Bid Addendum No. 1

Washingtonville Central School District – 2024 Capital Project - Phase 3

CSArch Project No. 228-2401.03

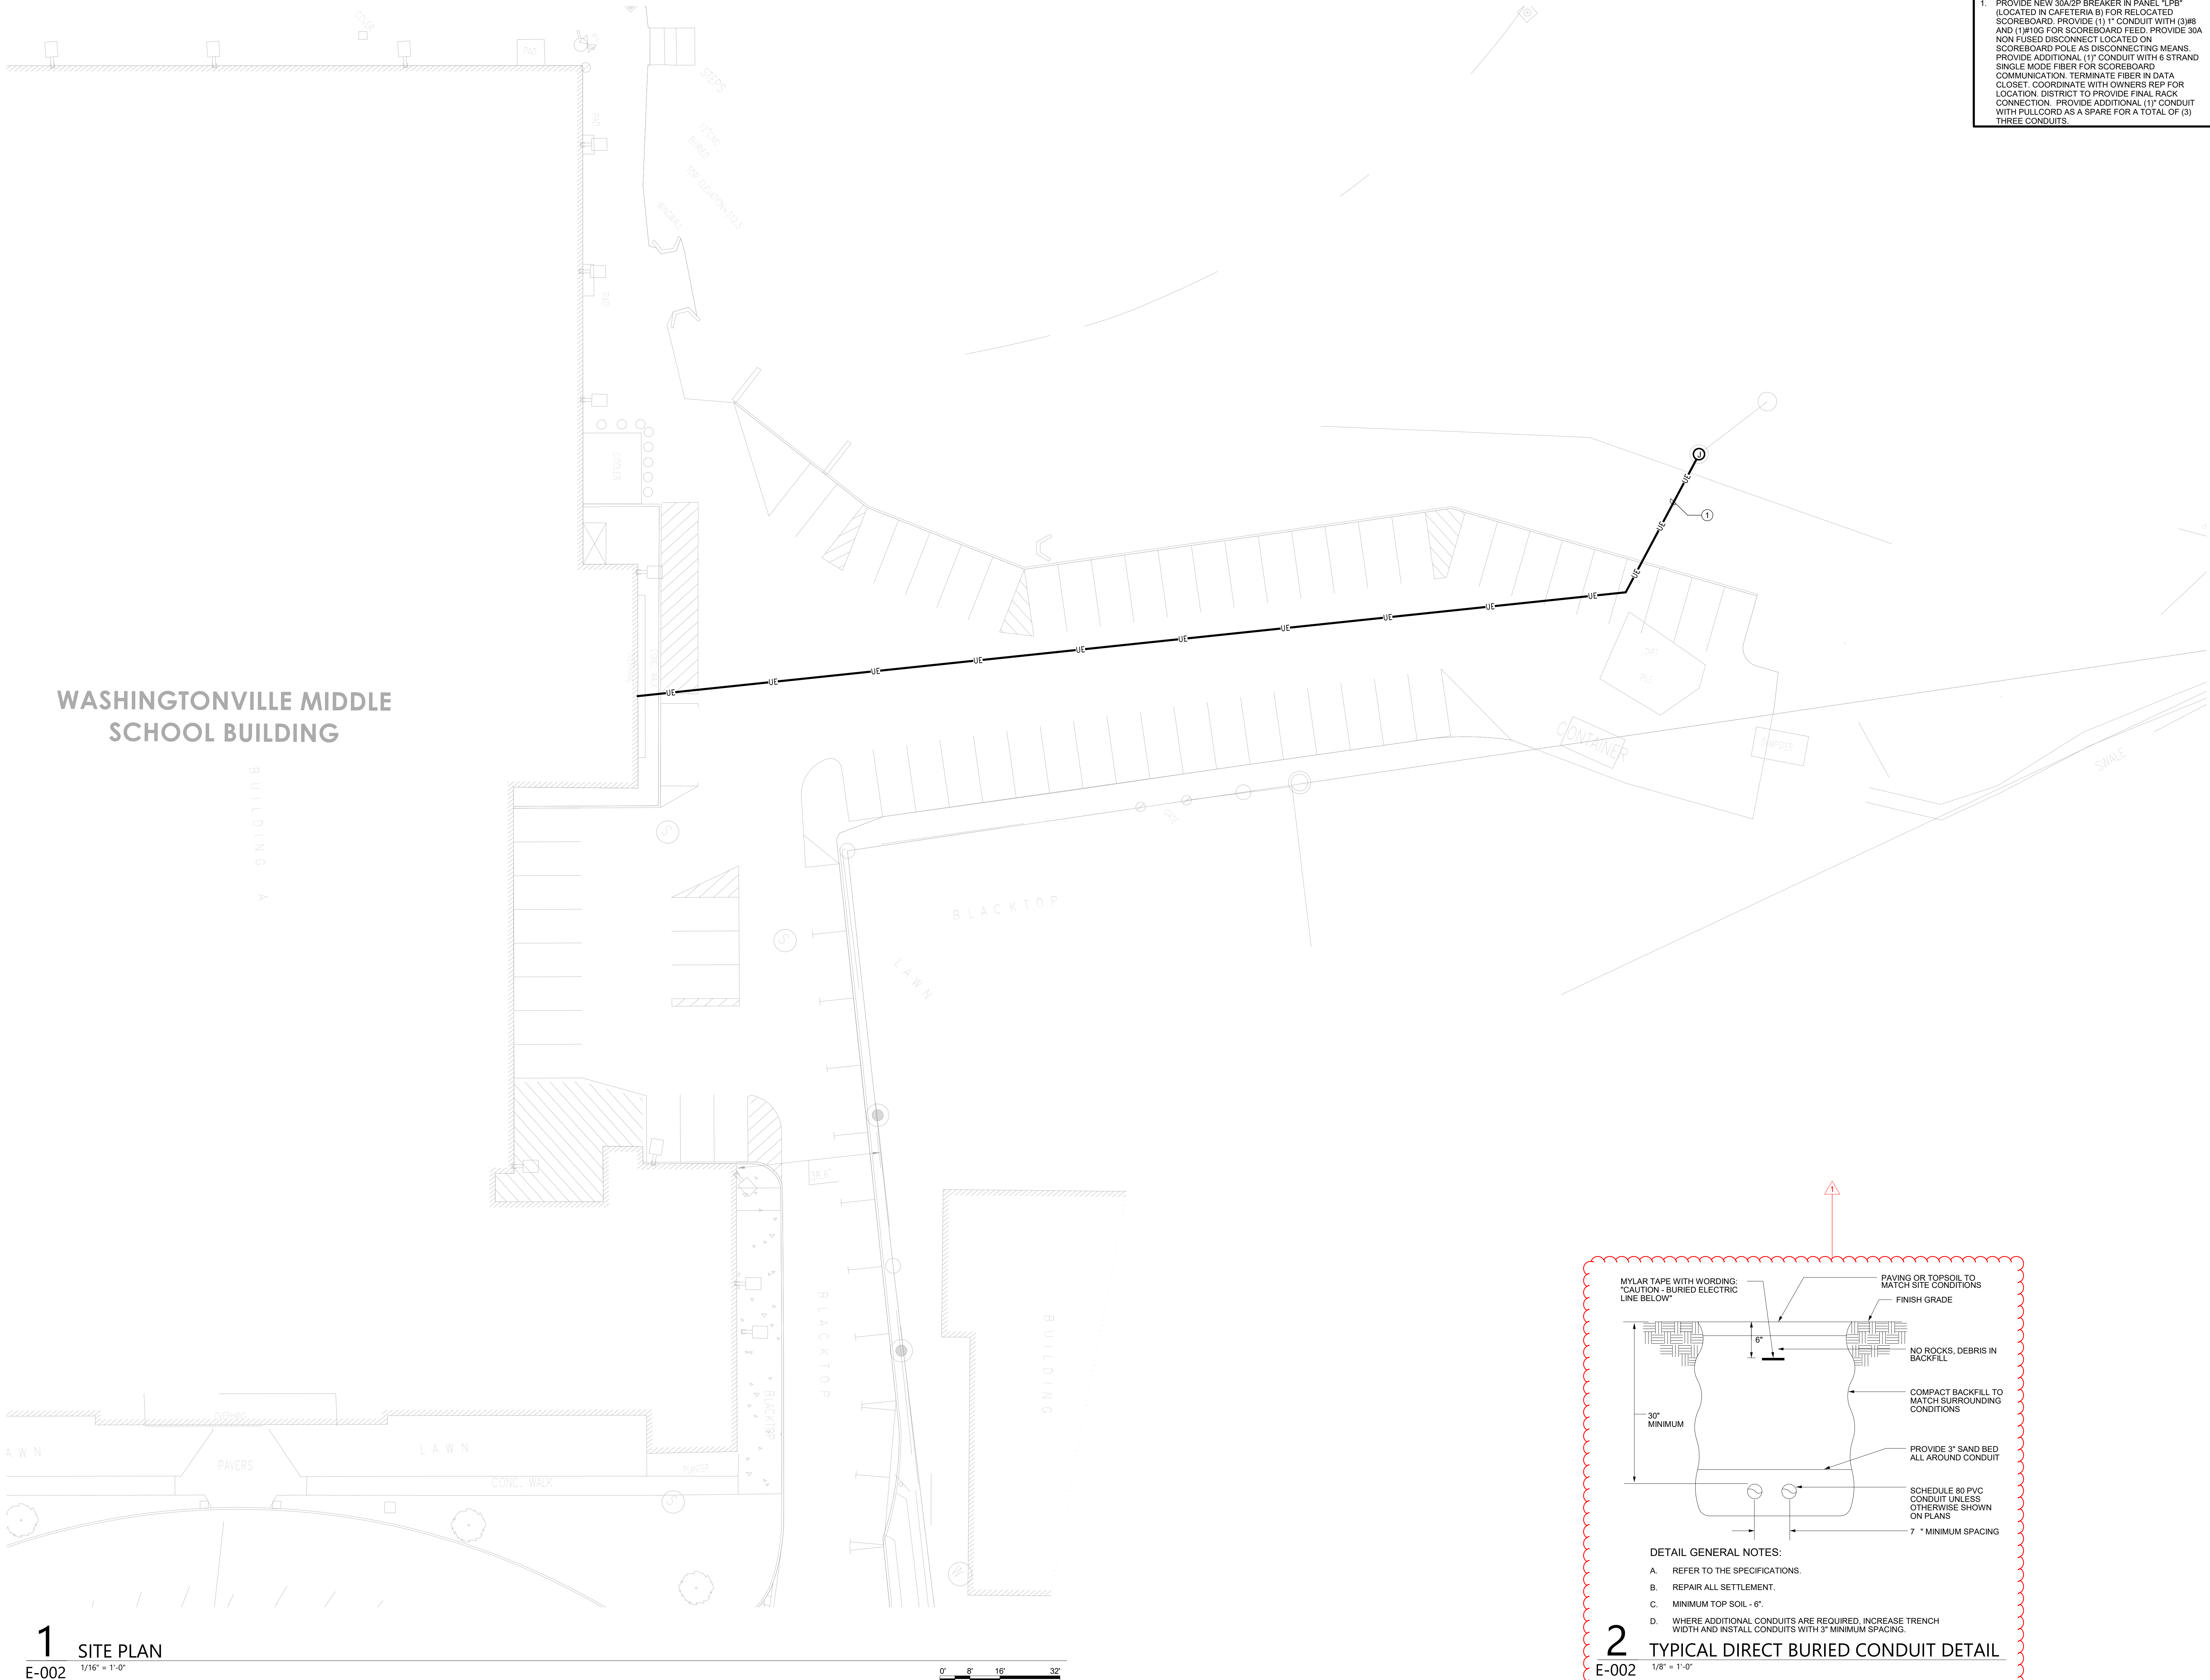
6. Please provide reference detail for Scoreboard Structure and Foundations regarding the relocated scoreboard at the WMS.
 - a. Response: *The structural and foundation details for the relocated scoreboard have been provided on revised drawing sheet WMS S001 included as part of this Bid Addendum.*

Sheet No.
WMS
E-002

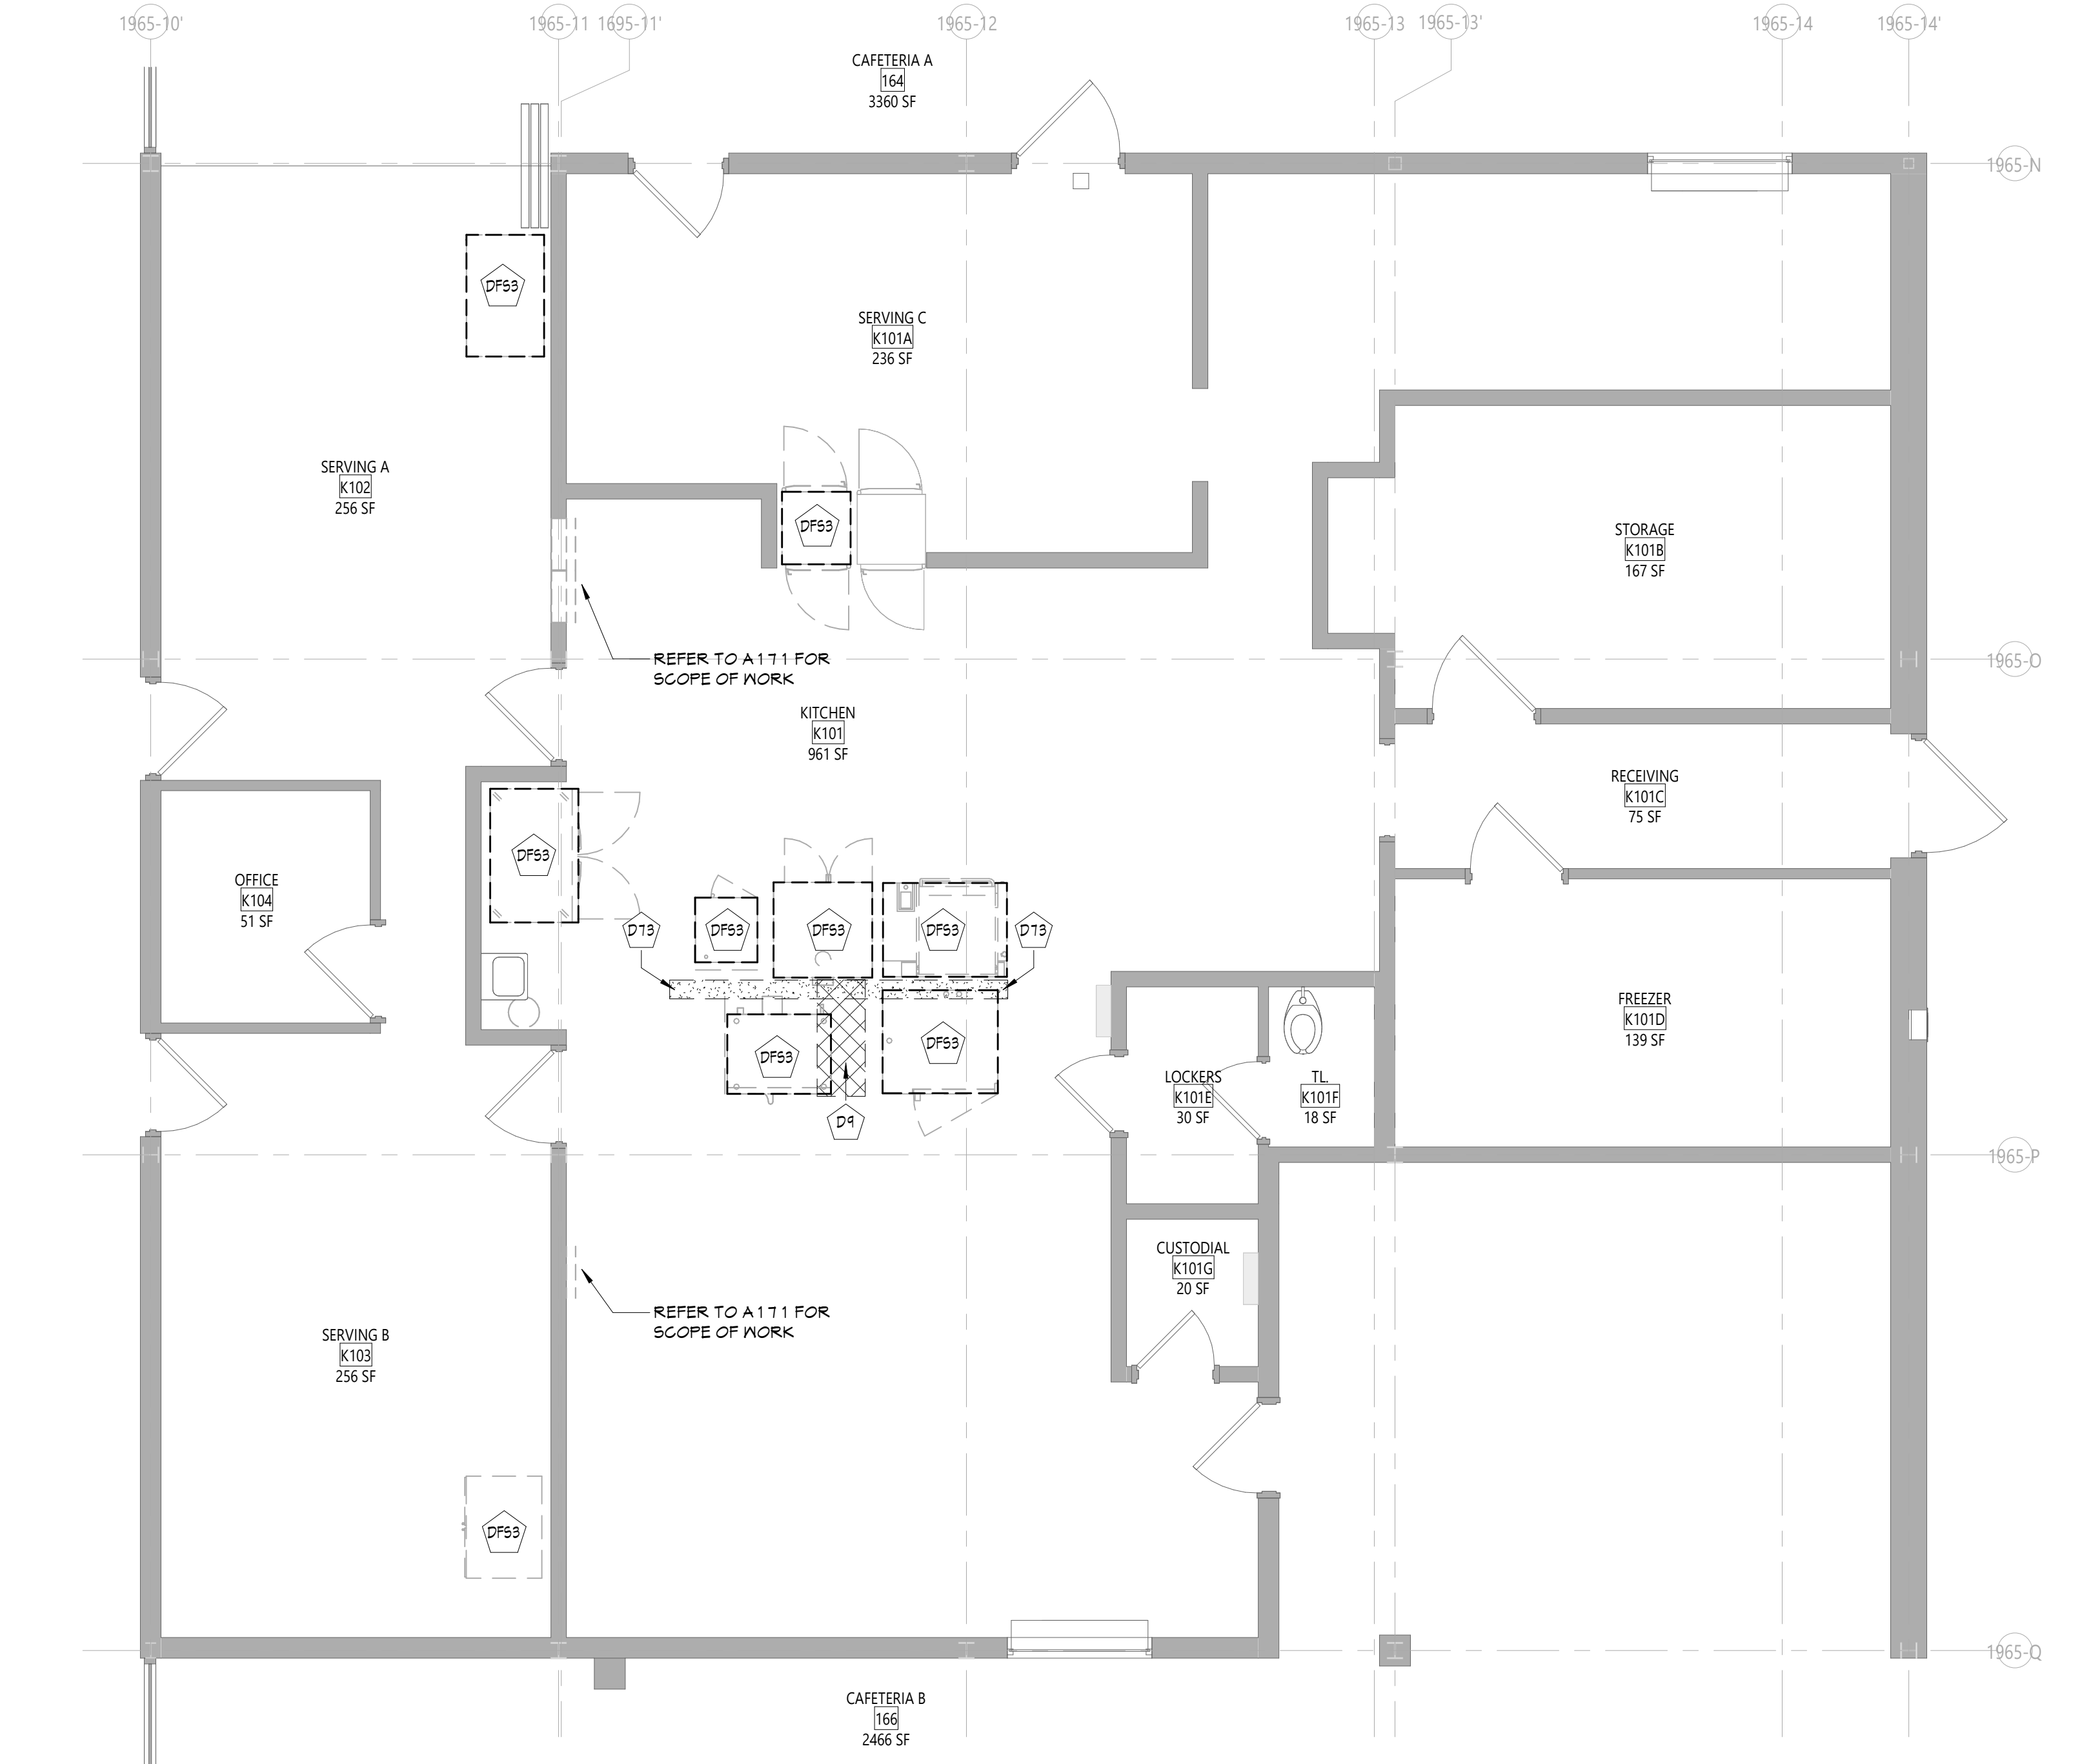
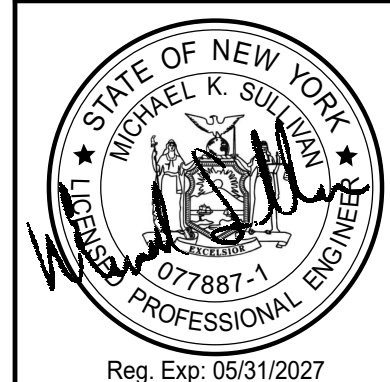
4. Sheet WMS E-002 - Define responsibilities between the Electrical & Sitework Contracts for work listed.
 - a. Response: *All work shown on drawing sheet WMS E-002 shall be completed by the Prime Electrical Contractor, including site excavation/trenching, sand bedding, compacted backfill, mylar tape installations, site restorations, conduit installations, power/communication cabling and wiring installations, installation of disconnect switches, terminations at data closet, terminations at scoreboard, breaker installations, and terminations at electrical panel. Owner to provide communications cabling connections at network rack.*
